FORESTSIDE TOWNHOUSES

SITE INSTRUCTION # 3

Date: May 7th, 2021

JAP Project No: 19066

Sheet Title	
4TH FLOOR BUILDING D	
North	 
Date Plotted	Date: May 07 2021
Drawn By: ND	Scale: 1 : 100
Checked By: JW	Revision Number:
Job No:	Sheet No:
19066	S-105A

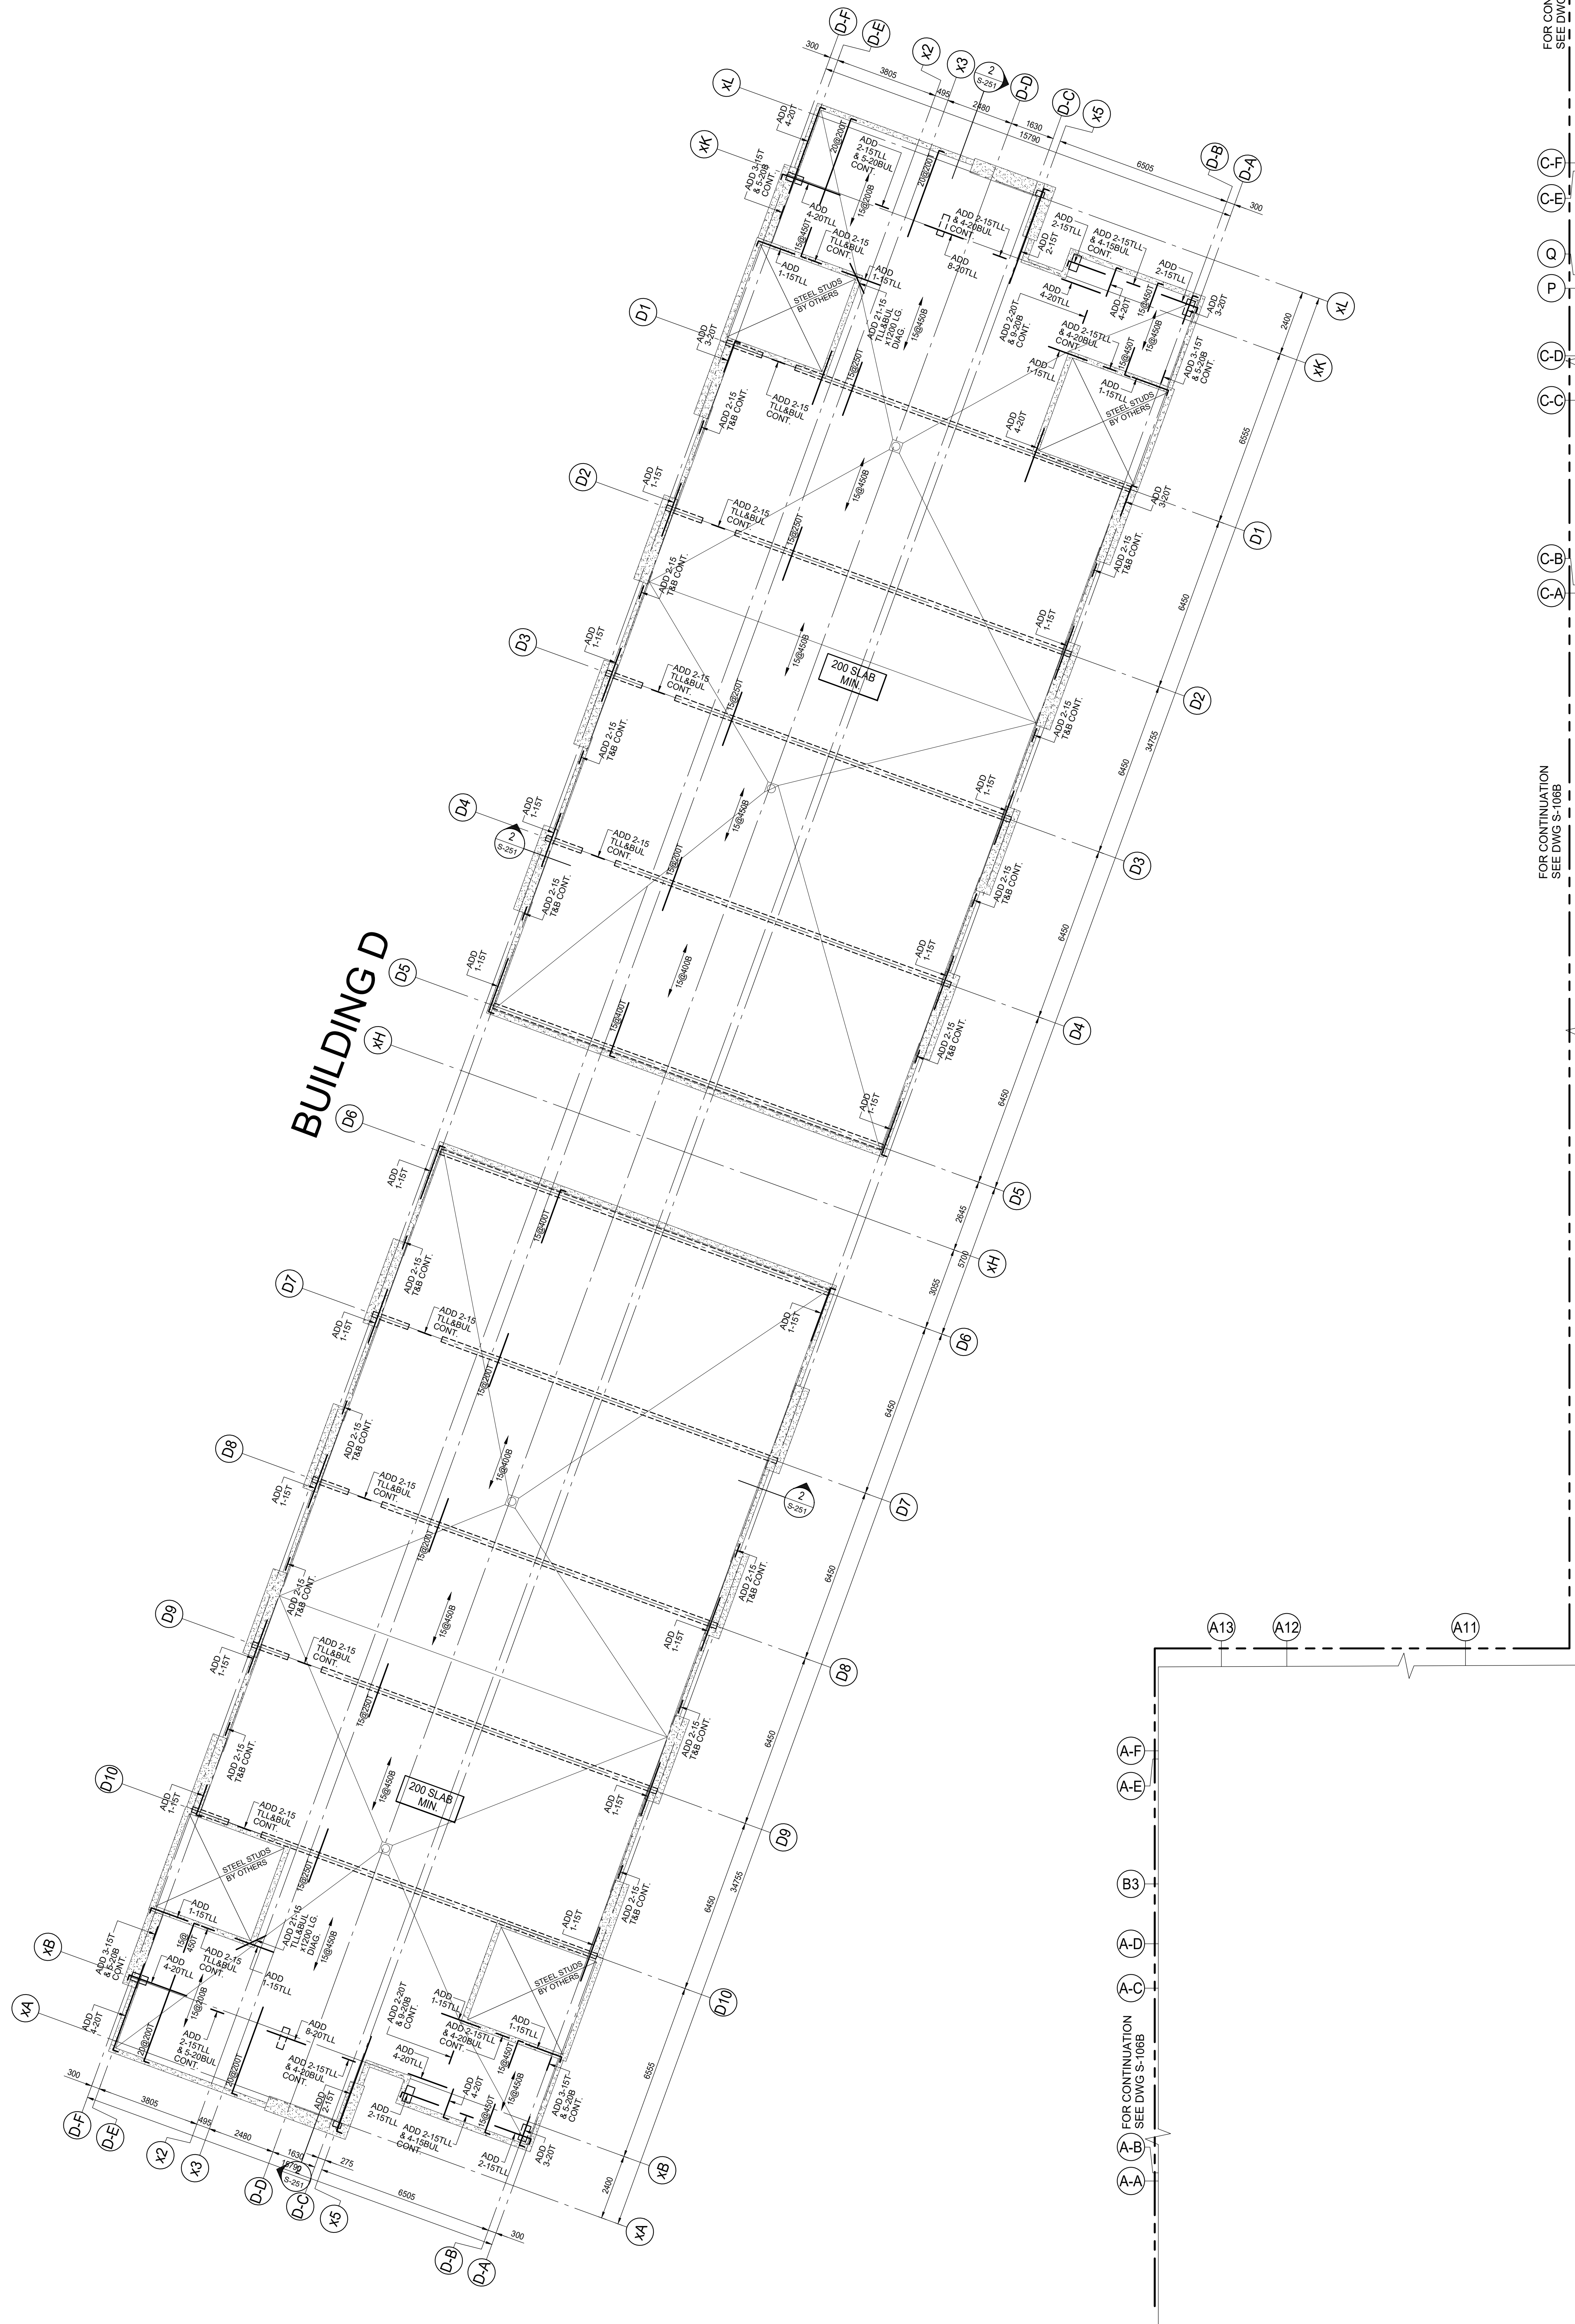
1.5 **Refer to Drawing S-105A "4th FLOOR FRAMING"**

- h) Updated concrete strengths
